SUBJECT: Responds to RAI on Shearon Harris IPEEE submittal. Info should be provided within 60 days of receipt of ltr to support NRC review per 971218 request.

SHEARON HARRIS NUCLEAR POWER PLANT
DOCKET NO. 50-400/LICENSE NO. NPF-63
RESPONSE TO REQUEST FOR ADDITIONAL INFORMATION
ON THE SHEARON HARRIS IPEEE SUBMITTAL (TAC NO. M83627)

**SHEARON HARRIS NUCLEAR POWER PLANT
DOCKET NO. 50-400/LICENSE NO. NPF-63
RESPONSE TO REQUEST FOR ADDITIONAL INFORMATION
ON THE SHEARON HARRIS IPEEE SUBMITTAL**

**Design Basis In-Structure Response Spectra Used for
Determination of B and C_c for Peak Clipping
(1 page)**

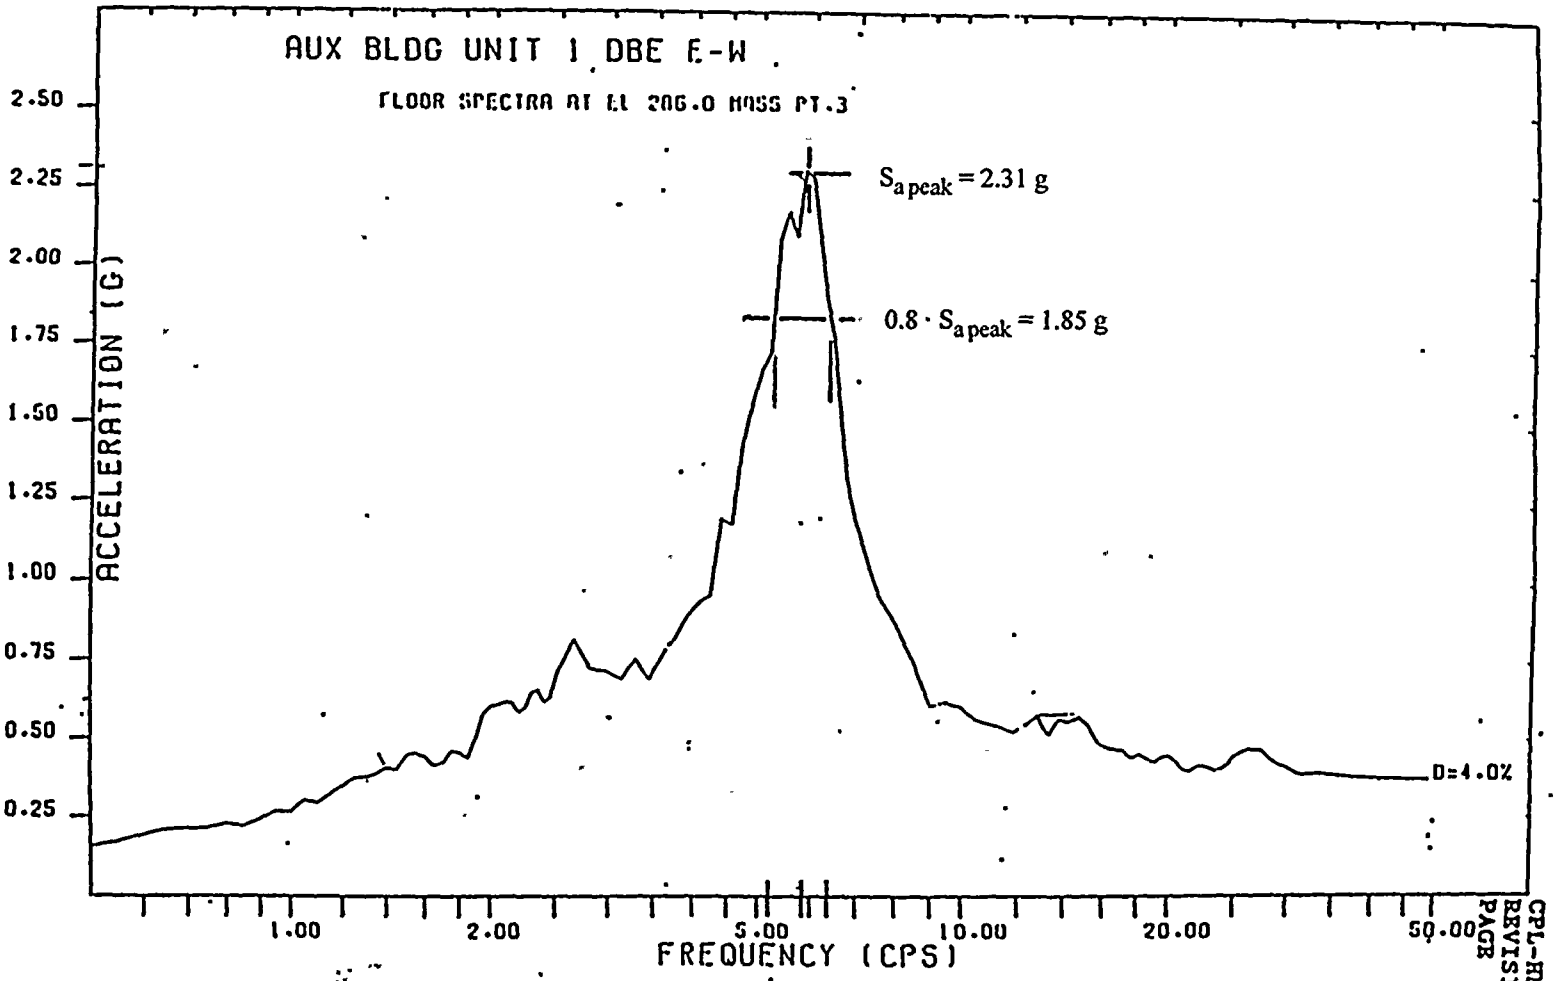
In Appendix A, Sec. 6.2, of the Shearon Harris IPEEE, a high-confidence-low-probability-of-failure (HCLPF) evaluation for the low voltage switchgear is described. It is stated that the initial analyses indicated a HCLPF significantly less than 0.3 g due to the low margin between the Test Response Spectrum (TRS) and the Required Response Spectrum (RRS). It is further stated that clipping was applied to the peak in the floor response spectra to reduce the Review Level Earthquake (RLE) seismic demand, thereby resulting in a HCLPF of 0.35 g for the low voltage switchgear. Please provide the justification for applying the peak clipping to the floor response spectra and provide the details of the calculation.

The low voltage switchgear were evaluated in accordance with Appendix Q, "Seismic Margin Capacity of Components Based Upon Seismic Testing," of EPRI NP-6041, "A Methodology for Assessment of Nuclear Power Plant Seismic Margin (Revision 1)." As discussed in Appendix Q, experimental observations indicate that narrow band frequency input is not as damaging as broad band frequency input. Since the design basis seismic qualification for this switchgear includes broad-frequency content spectra and the in-structure floor spectra have narrow frequency peaks, methodology from Appendix Q was applied. The most limiting case includes $B = 0.19$ (Equation Q-2) and $C_c = 0.55$ (Equation Q-6). The peak in-structure demand for the 0.3 g RLE was reduced from 3.624 g to 2.0 g (5% damping) for this case. Included as Attachment 1 to this enclosure is a copy of the design basis response spectrum used to determine B and C_c for the limiting case discussed above. Two additional details must also be discussed:

- The spectrum included in Attachment 1 is the design basis spectrum which was scaled to determine in-structure demand for the 0.3 g RLE. Refer to the Seismic IPEEE Report Appendix C for a discussion of the determination of scale factors.
- This spectrum is for 4% damping, but was conservatively used as 5% damping.
